Marion County

Development Review Committee

Meeting Agenda

Monday, November 24, 2025

DATE	REVISED	BY
 CFB CLYMER FARMER BARLEY, INC. 1113 ALFORD AVENUE MOULTON, FL 32063 (904) 748-3126		
AZALEA SKILLED NURSING FACILITY MAJOR SITE PLAN MARION COUNTY, FLORIDA DETAILED SITE PLAN		
DATE	5/23/2025	
DRAWN BY	JT	
CHECKED BY	TC	
PROJECT #	89204-00005	
FILE NAME		
SHEET NUMBER 06

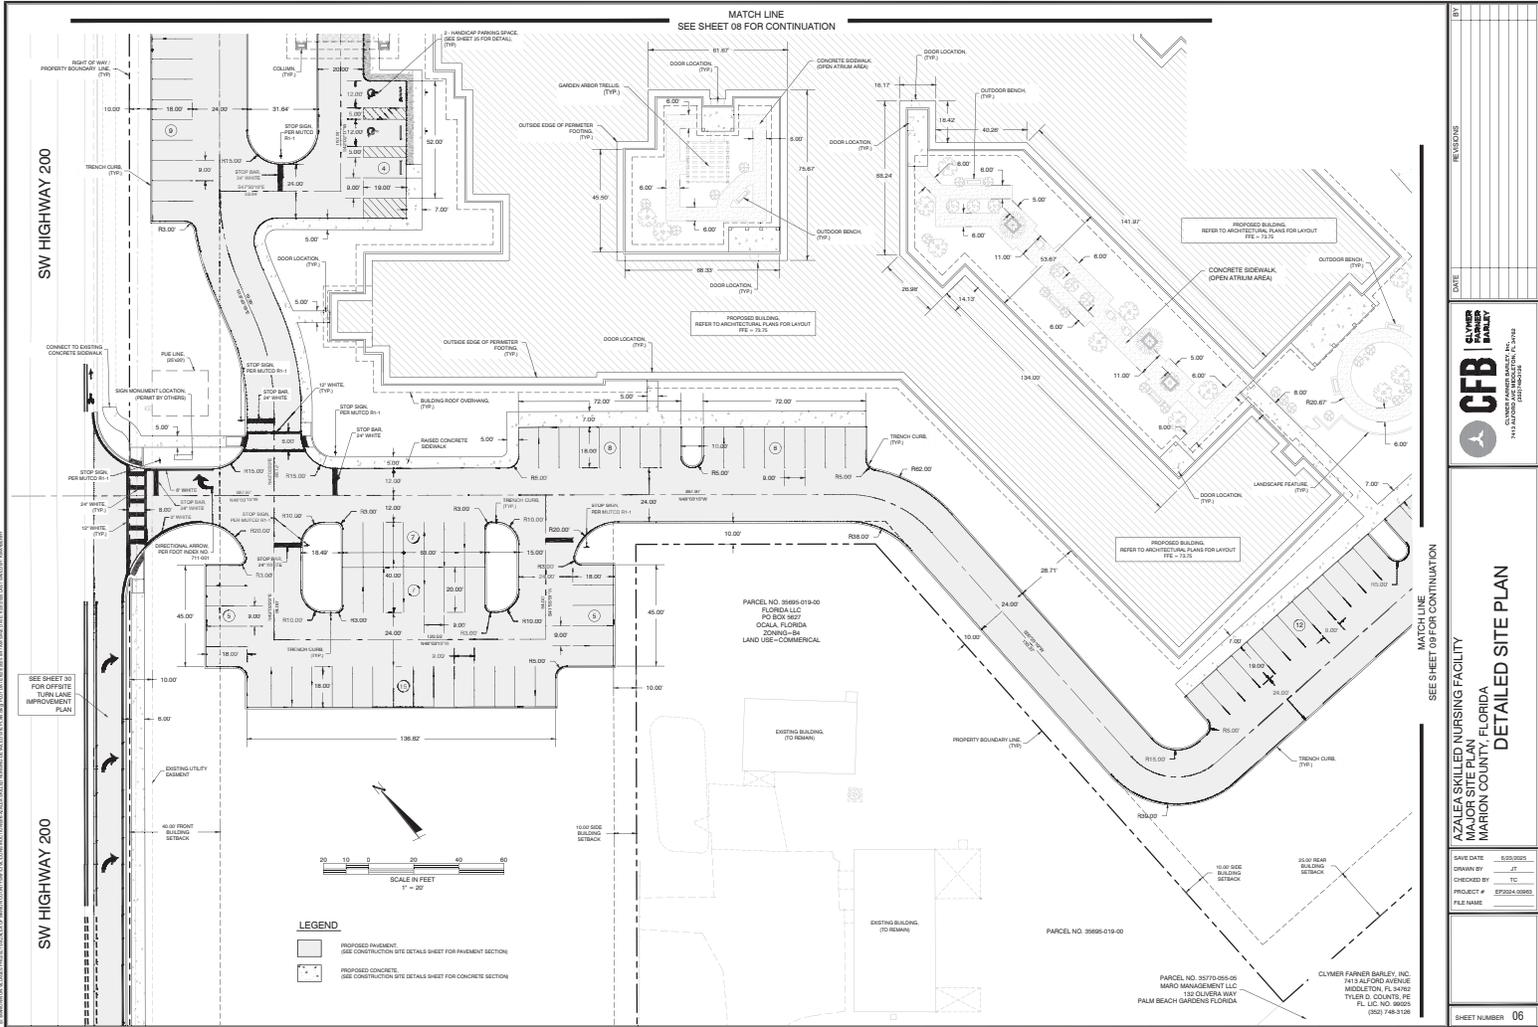
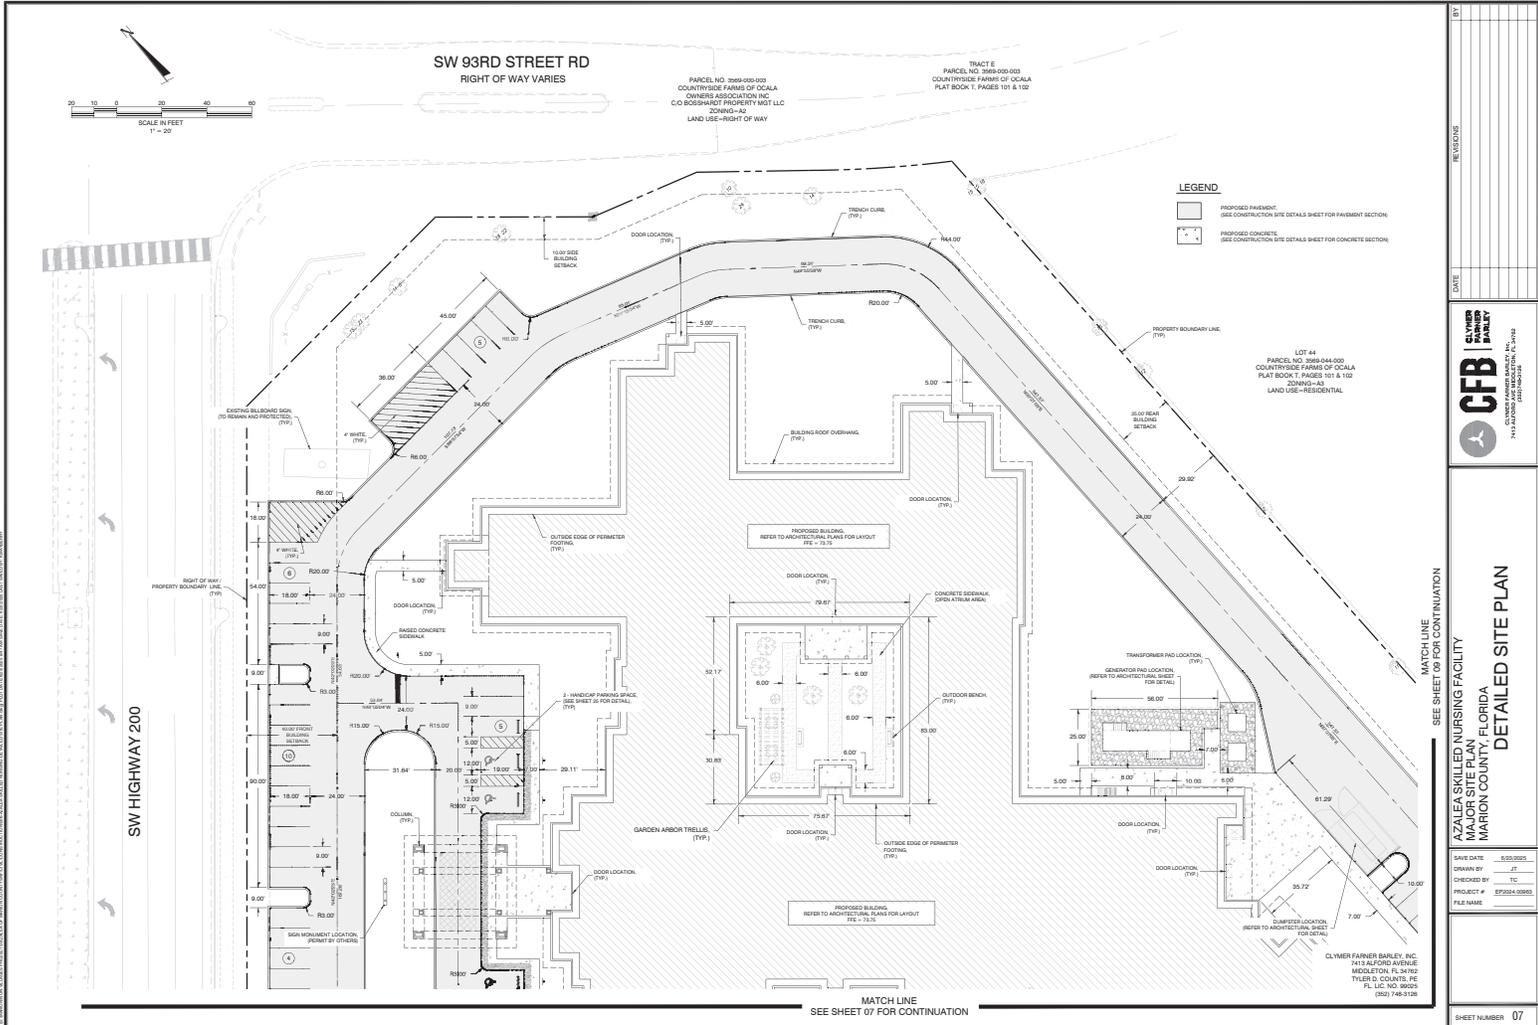
[1] Buffers need to be shown, dimensioned and labeled on the site plan sheets 5 through 8, consistent with the landscape plan. For the Type B buffer along the site's east boundary, specifically label the buffer as a Type B Buffer w/ 6' pillar/panel buffer wall.

[2] The 06-24-25 LS sheet states there should be a 15' Type C buffer along SW 200 Hwy. However, on 06 Detailed Site Plan v2, the space between SW 200 property line and parking shown as 10'. This 10' space seems to extend to sheet 07, but the space is not dimensioned. How will a 15' Type C buffer be provided in this 10' space?

5' setback is required per 4.4.4.F(2). This comment is [INFO] instead of [NO] to help expedite plan approval. Please show 5' setback for the monument sign shown on sheets 05 and 06 when submitting the plan set for DRC stamp of approval.
